Monticello Nuclear Generating Plant
Operated by Nuclear Management Company, LLC

Response to Requests for Additional Information Regarding the Monticello Nuclear Generating Plant License Renewal Application (TAC No. MC6440)

RESPONSE TO NRC REQUEST FOR ADDITIONAL INFORMATION DATED SEPTEMBER 28, 2005

Figure 1
Relaxation of Irradiated Austenitic Steels & Ni-GE Mean Design Curve

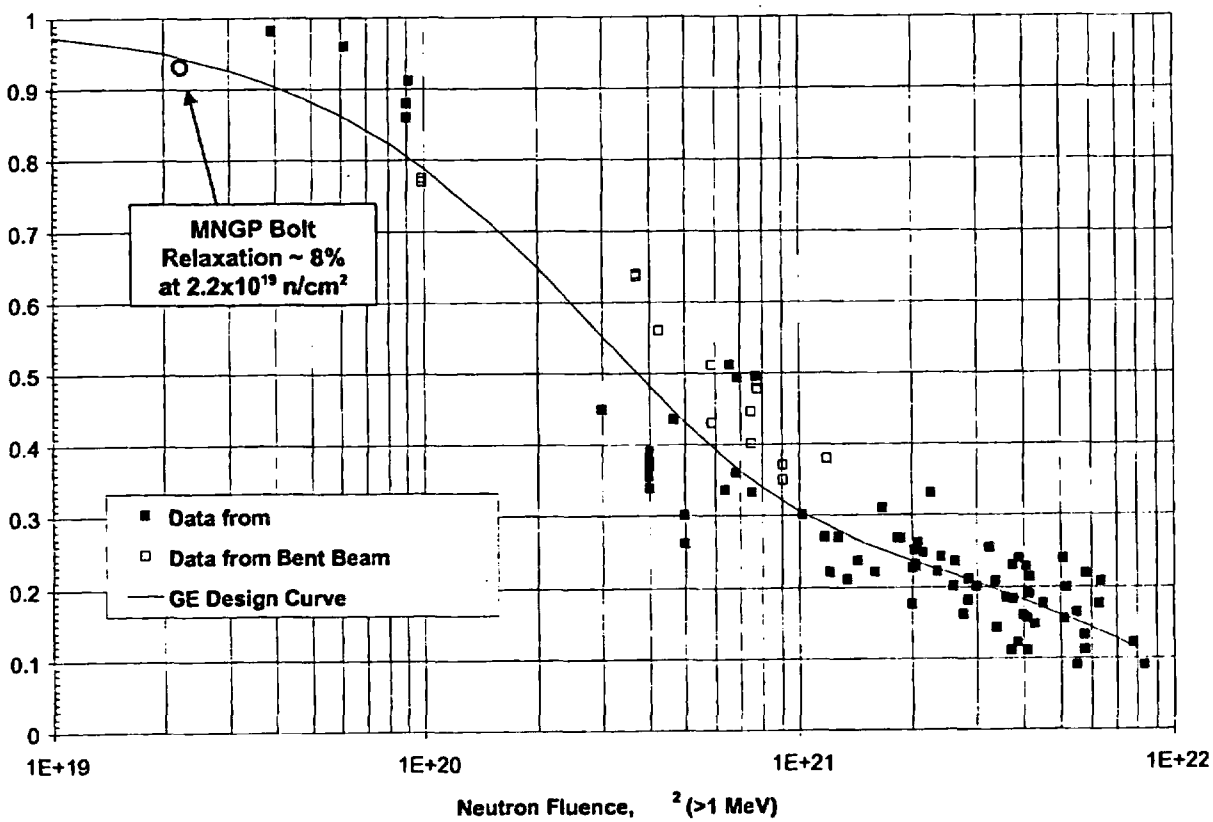
a. Provide the stress-relaxation curves and their supporting data that were utilized to determine the percent relaxation of the rim holddown bolts at MNGP. Explain how this data was utilized to establish the curves.

d. Based on the stress relaxation curves provided in response to RAI 4.8-2(a) describe how the value of 8 percent stress relaxation was determined for the rim holddown bolts at MNGP.

Figure 1, "The Relaxation of Irradiated Austenitic Steels and Ni," shows the GE mean design curve along with the data used for its derivation. The curve is based on a model that assumed a stress-linear, primary plus secondary creep law form, and was fit to the shown data using stepwise multiple regression. The data presented as closed symbols are from measurements made on springs, and the data shown as open symbols are measurements made using bent-beam specimens.

d. A MNGP specific bolt average fluence of 2.2×10^{19} n/cm^2 (E>1MeV) was calculated at the peak fluence location. Given that the fluence on the core plate bolts varies depending on the azimuthal location, with a significant fraction of the bolts at less than the peak fluence, this provides an additional conservatism for most bolt locations. The MNGP specific fluence of 2.2×10^{19} n/cm^2 (E>1MeV) was then compared to the original, hand drawn GE design curves to determine a value of 8% relaxation. Figure 1 is a re-plotted version of the GE design curve that shows a computer generated curve fit of the same data. The value of 8% relaxation is conservative relative to the statistical curve fit shown in Figure 1.

Figure 2
Stress Relaxation Data from Halden
(Shown as Figure 7-17 in BWRVIP-99).

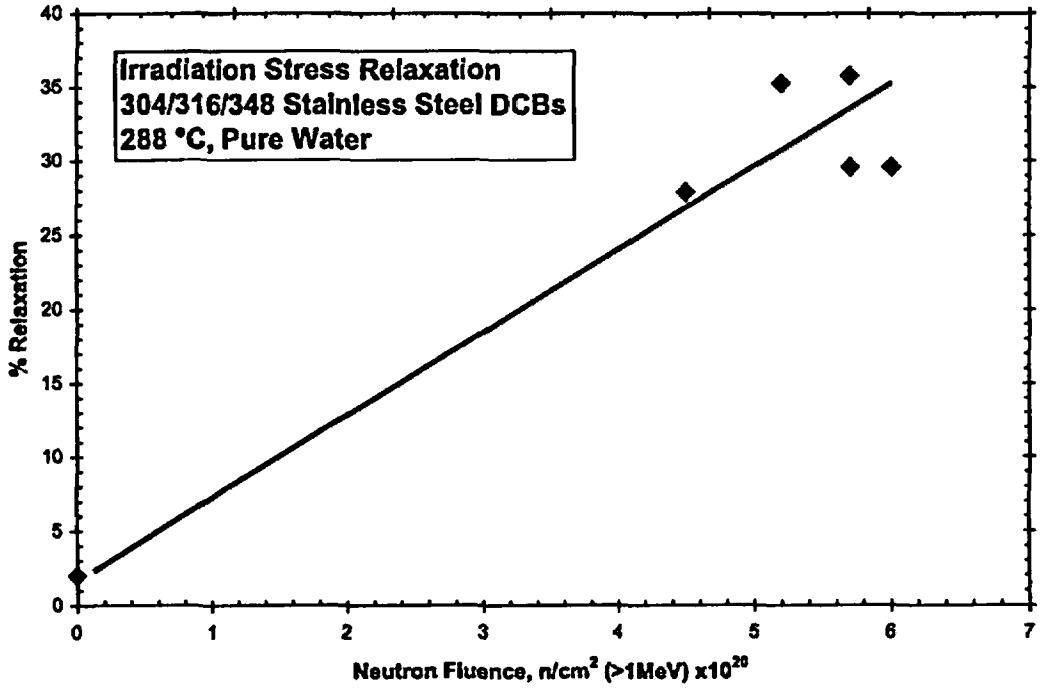
b. The staff requests that the applicant provide information regarding the material type, (i.e., type 304 or type 316, etc.), values of neutron flux and temperature related to the data cited in response to RAI 4.8-2(a) and compare them to the type of material, neutron flux and temperature values of the rim holddown bolts at MNGP. If the type of material, neutron flux or temperature values for the rim holddown bolts at MNGP are different than that for the data, evaluate the impact of these differences on the predicted stress relaxation values of the rim holddown bolts at MNGP.

To further support this observation, see Figure 7-17 in the BWRVIP-99 report, "Crack Growth Rates in Irradiated Stainless Steels in BWR Internal Components" (repeated here as Figure 2). This figure shows stress relaxation data from wedge loaded DCB specimens in 288°C water at Halden that are exposed to neutron fluences of approximately 4.4 to 6 x 10^{20} n/cm^2 (>1 MeV) (i.e. ~0.6 to 0.9 dpa). This data shows stress relaxation levels clustered between 28% and 36% for DCB specimens fabricated from 304/316/348 stainless steels. It should be noted that this data is for fluence levels nearly 10 times higher than that predicted for the MNGP bolts, and that the effects at lower fluences would be expected to be less pronounced.
